NRC 2001-0010

DOCKETS 50-266 AND 50-301
SUPPLEMENT 11 TO APPLICATION FOR AMENDMENT TO
FACILITY OPERATING LICENSE APPENDIX A:
TECHNICAL SPECIFICATIONS IMPROVEMENT PROJECT
RESPONSE TO RAI ON ITS SECTIONS 3.3.2 THROUGH 3.3.5 AND FOLLOWUP QUESTIONS
POINT BEACH NUCLEAR PLANT, UNITS 1 AND 2

DOCKETS 50-266 AND 50-301
RESPONSE TO REQUEST FOR ADDITIONAL INFORMATION
TECHNICAL SPECIFICATIONS IMPROVEMENT PROJECT
SECTIONS 3.3.2 THROUGH 3.3.5 AND FOLLOWUP STAFF QUESTIONS
POINT BEACH NUCLEAR PLANT UNITS 1 AND 2

Table 3.3.2-1 (page 7 of 8)
Engineered Safety Feature Actuation System Instrumentation

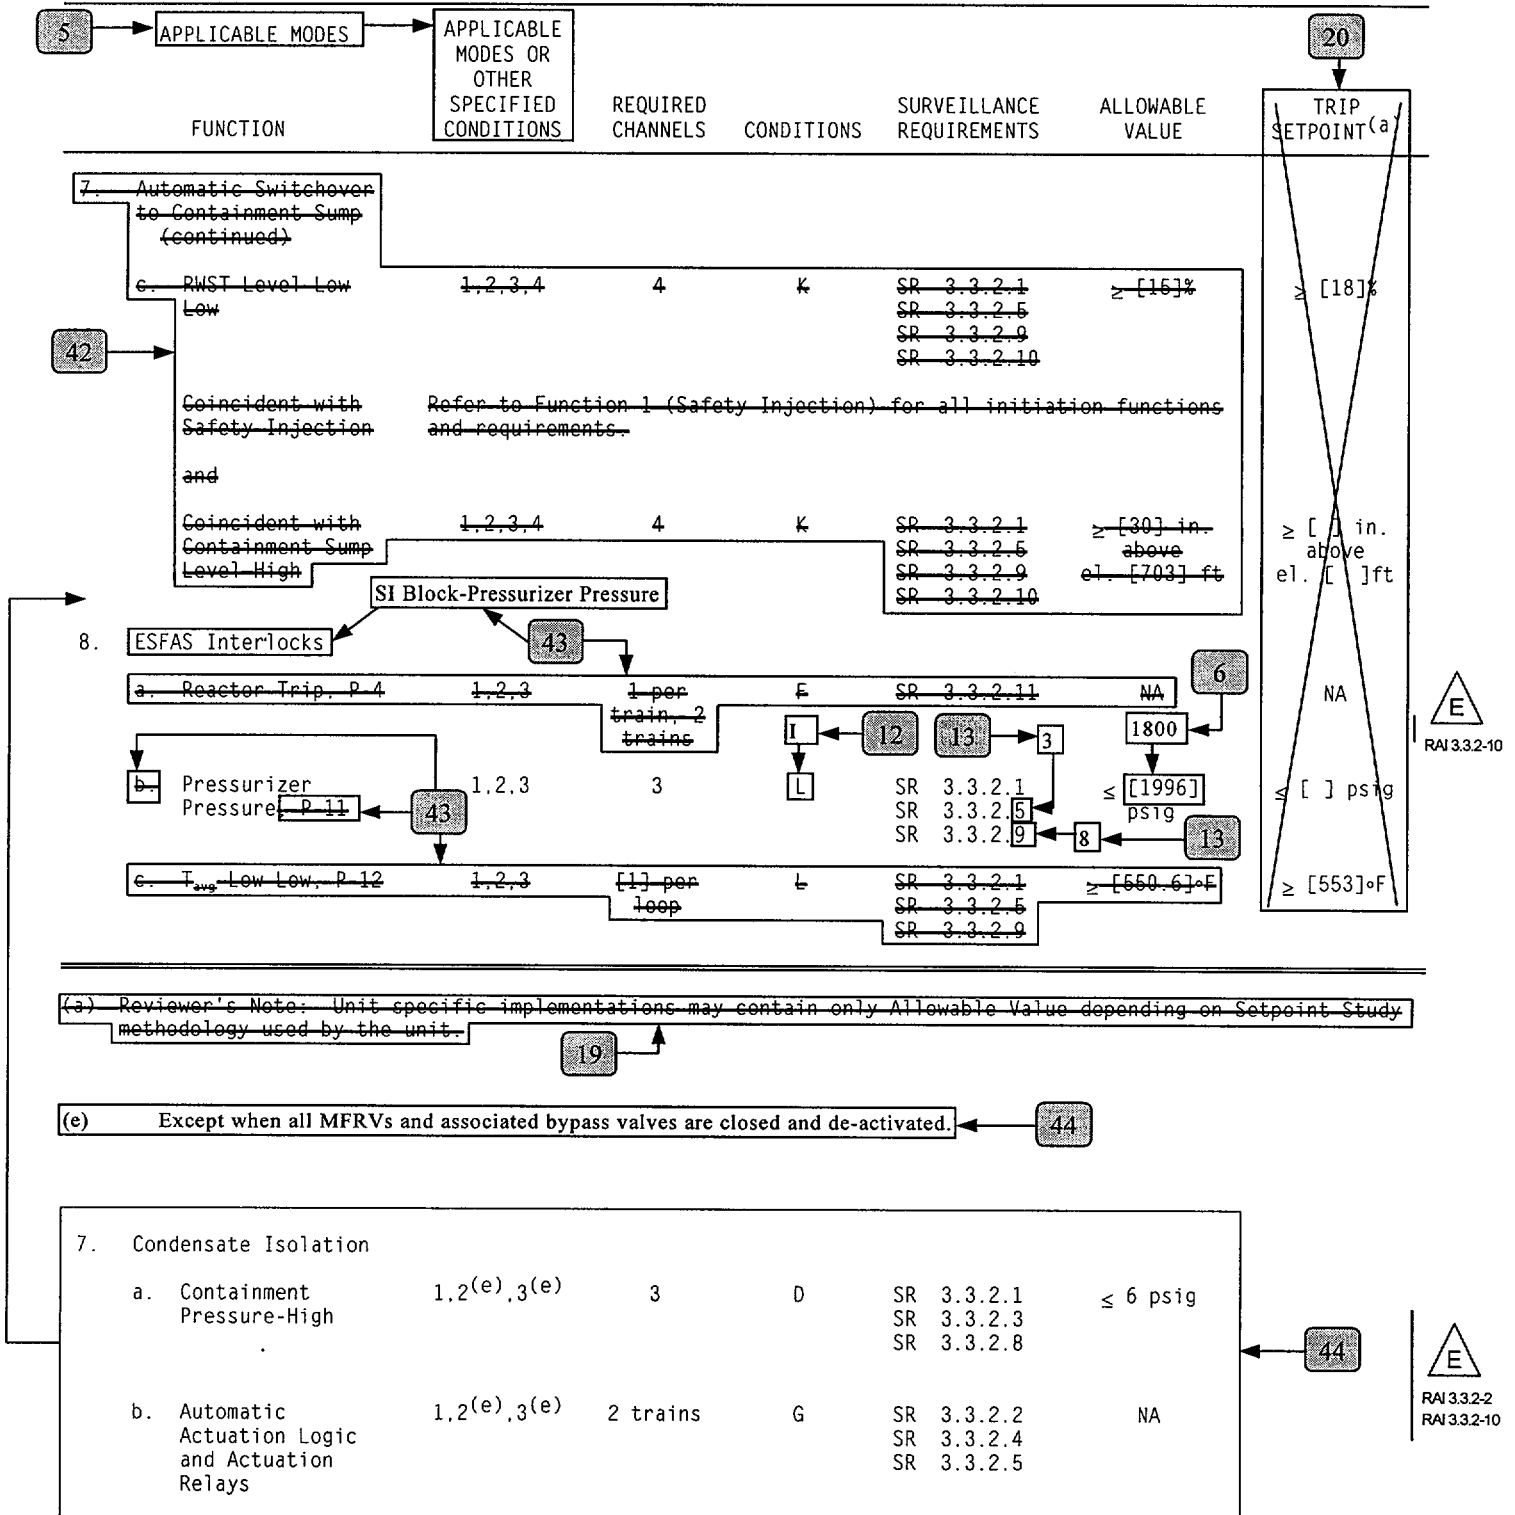
The CTS provides no Trip Setpoint for the Steam Generator Water Level High function. The ITS also provides no Allowable Value for this function, contrary to the STS. Comment: The standard format requires that a Trip Setpoint and / or Allowable Value be provided for the function. Providing no setpoint is functionally equivalent to deleting the function which is unacceptable. Provide the proper Trip Setpoint and / or Allowable Value consistent with the resolution of comment 3.3.2-01.

4. Per Errata #160, NUREG-1431, LCO 3.3.2, Table 3.3.2-1, Functions 6.g, AFW – Trip of All MFW Pumps, should not be retained in ITS. Point Beach ESFAS design does not include this function as an AFW actuation signal. As a result of this comment, the AFW – Trip of All MFW Pumps Actuation has not been retained in ITS. This also results in the deletion of the associated Required Actions and Bases. Justification for not retaining this function is contained in JFD 40.

E
RAI 3.3.2-2
Errata #160

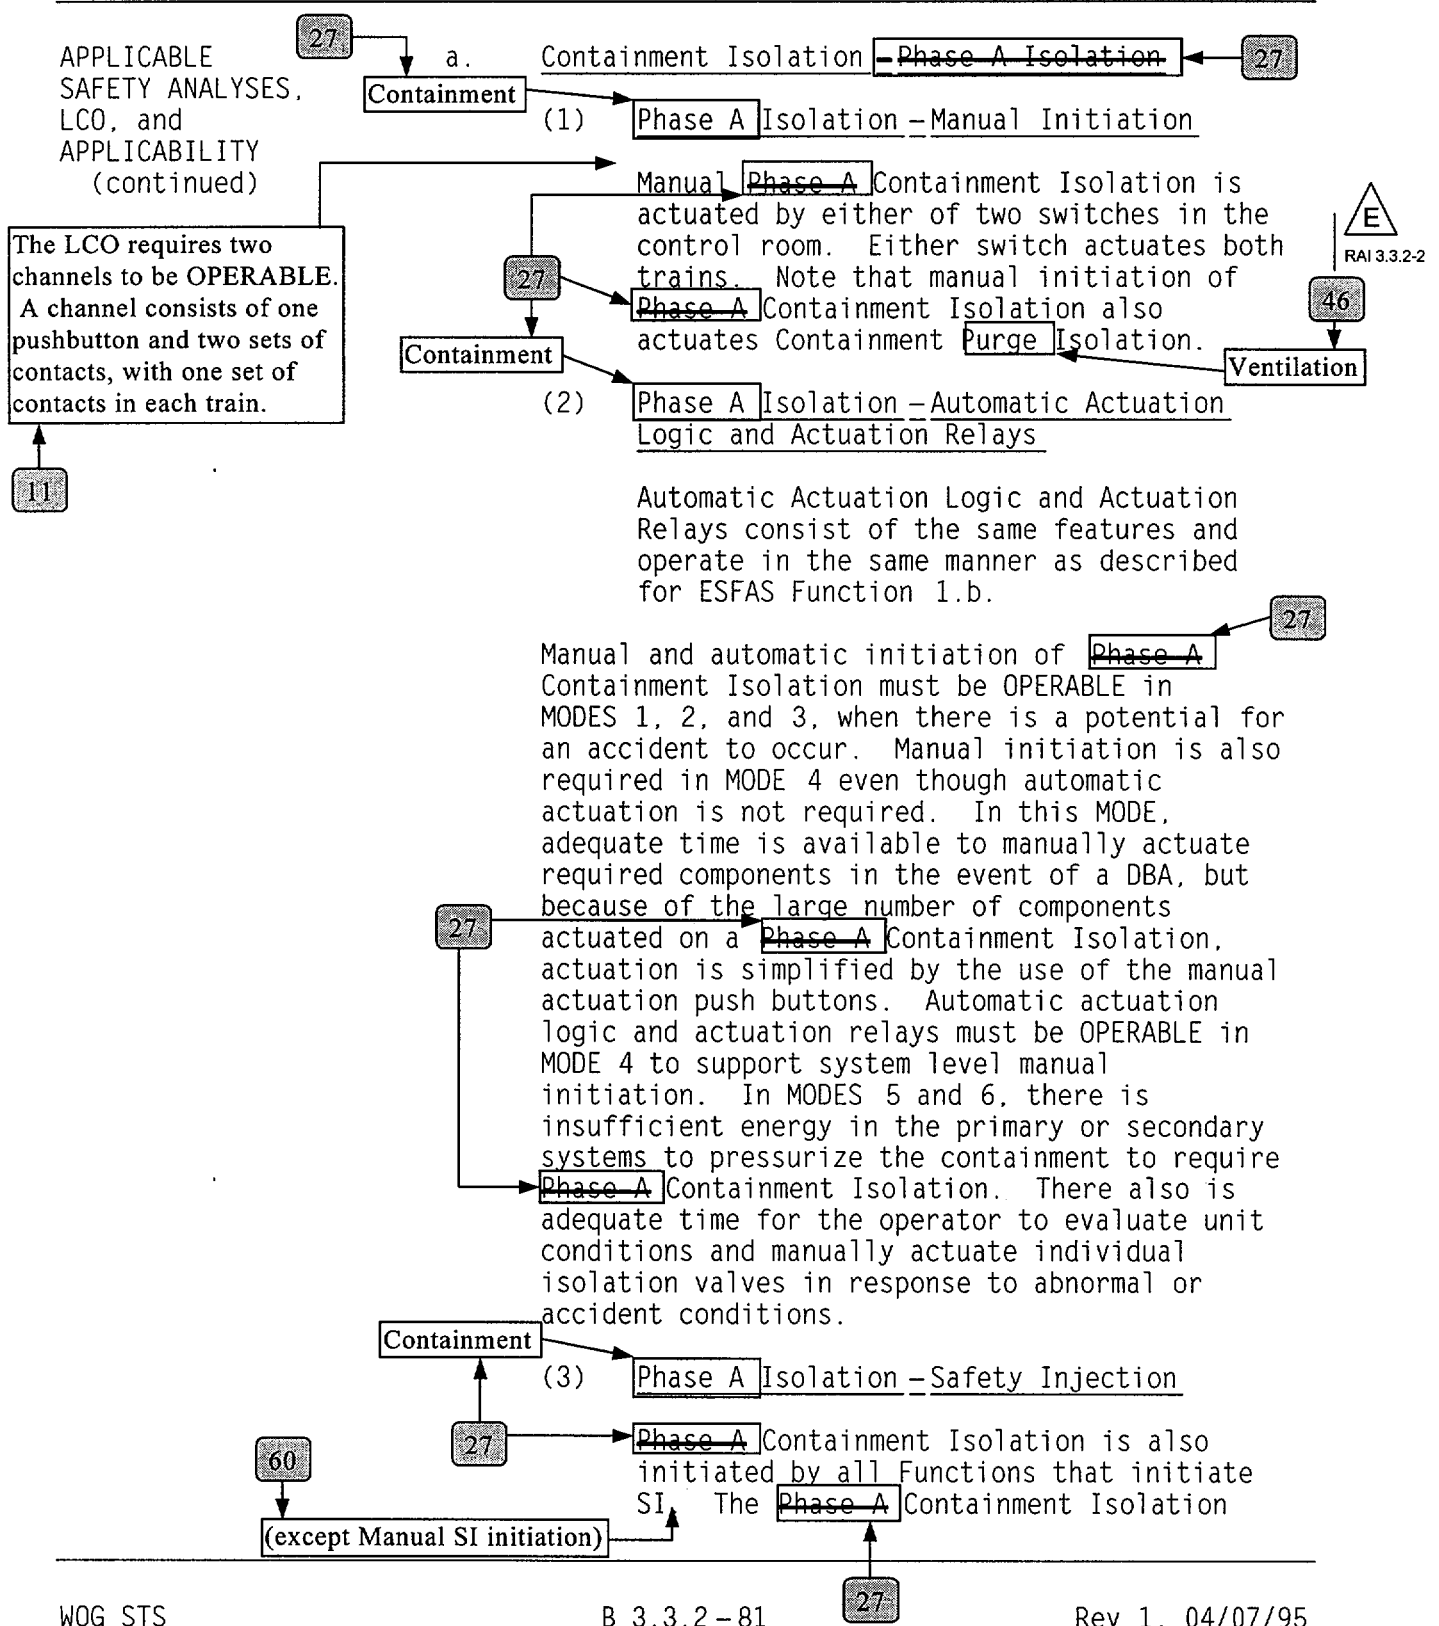
the total number of channels. For most functions the ITS sets the Required Channels equal to Total Number of Channels. For Functions listed above the ITS specifies the CTS Minimum Operable Channels instead of the Total Number of Channels. Comment: The STS format is to use the total number of channels in the Required Channels column. Use of the CTS Minimum Operable Channels is inconsistent with the STS format. Use of Minimum Operable Channels for these functions while Total Number of Channels is used for all other functions also creates an internal inconsistency in the ITS. Revise the ITS to use total number of channels. This will also require revision of the related ITS actions to be consistent with the condition of one channel inoperable and the STS.

E
RAI 3.3.2-2

D.1, D.2.1, and D.2.2 (continued)

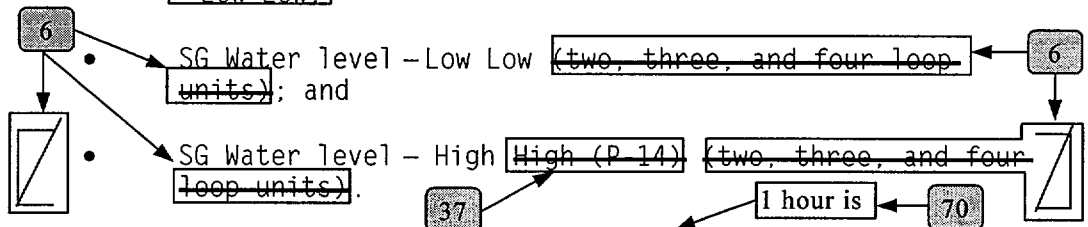
The CTS allows continued operation with one channel inoperable if the affected channel is placed in trip within one hour. The ITS actions adopt the STS requirement to place the channel in trip within 6 hours. Comment: The extended Completion Time in ITS Action D, is justified in

The Completion Time of Required Action D.1 has been changed to one hour, consistent with the CTS requirement. Justification for this change is provided in JFD 70.

TABLE 15.3.5-5
INSTRUMENT OPERATING CONDITIONS FOR POST ACCIDENT MONITORING INSTRUMENTATION

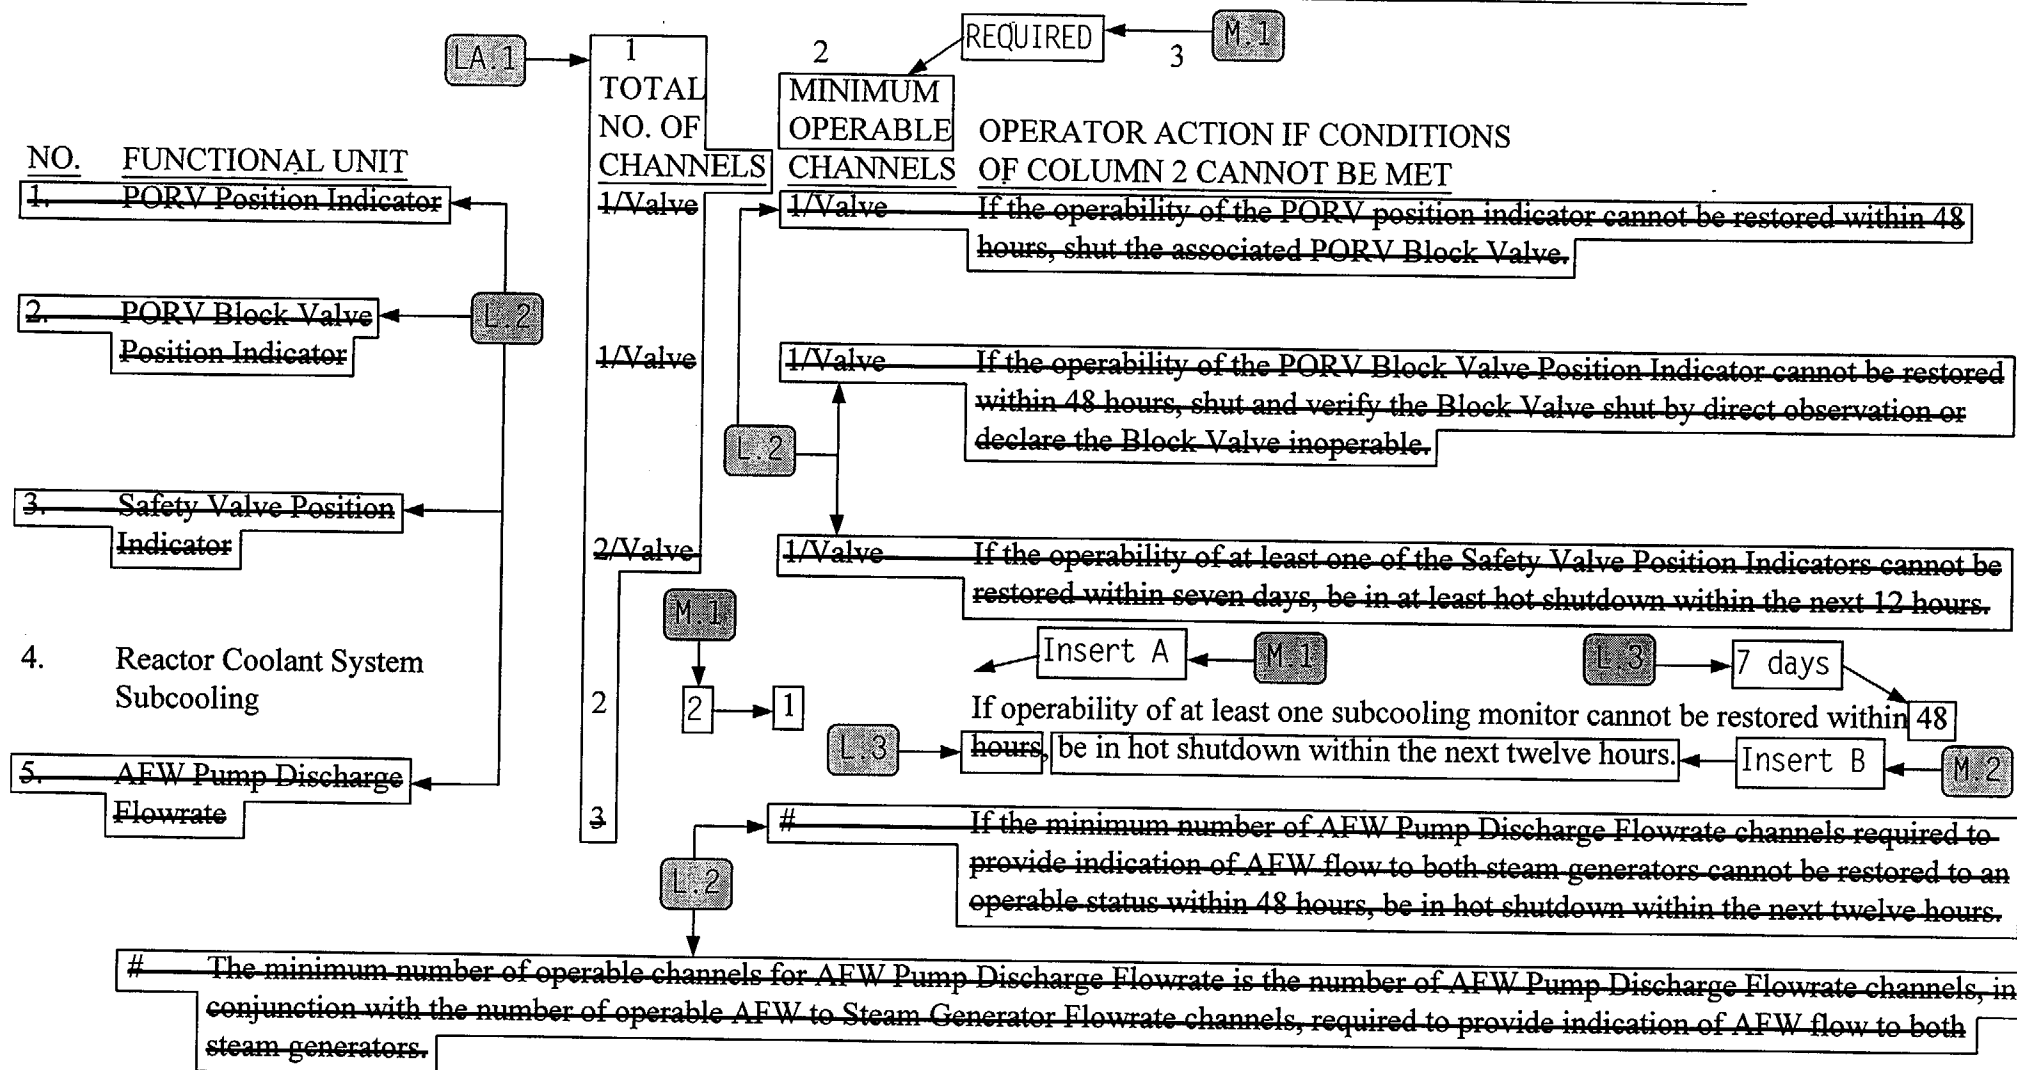
The CTS specifies that there are 2 AFW flow channels and a minimum of 1 AFW flow channel required Operable. The STS requires 2 AFW flow channels to be operable. The ITS requires 1 channel/steam generator to be Operable. Comment: The ITS requirement may allow operation with only one flow channel, depending upon the arrangement of the AFW system. Adopt the STS requirement of two AFW flow channels.

The CTS specifies that the plant be placed in hot shutdown if at least 1 AFW flow channel is not Operable. The ITS allows operation to continue indefinitely with no Operable AFW flow indication. DOC L.4 justifies this because AFW flow is a Category II backup indication. Comment: If AFW flow is included in Table 3.3.3-1, it should be either Category I or Class A. If it is not Category I, then it must be a Class A variable. Therefore, it should be treated with equal importance as other PAM variables. Adopt the STS requirement to enter Condition F if no channels are operable.

NO.	FUNCTIONAL UNIT	TOTAL NO. OF CHANNELS	MINIMUM OPERABLE CHANNELS	OPERATOR ACTION IF CONDITIONS OF COLUMN 2 CANNOT BE MET	M. 2 → Insert B L. 3 RAI 3.3.3-1 RAI 3.3.3-2
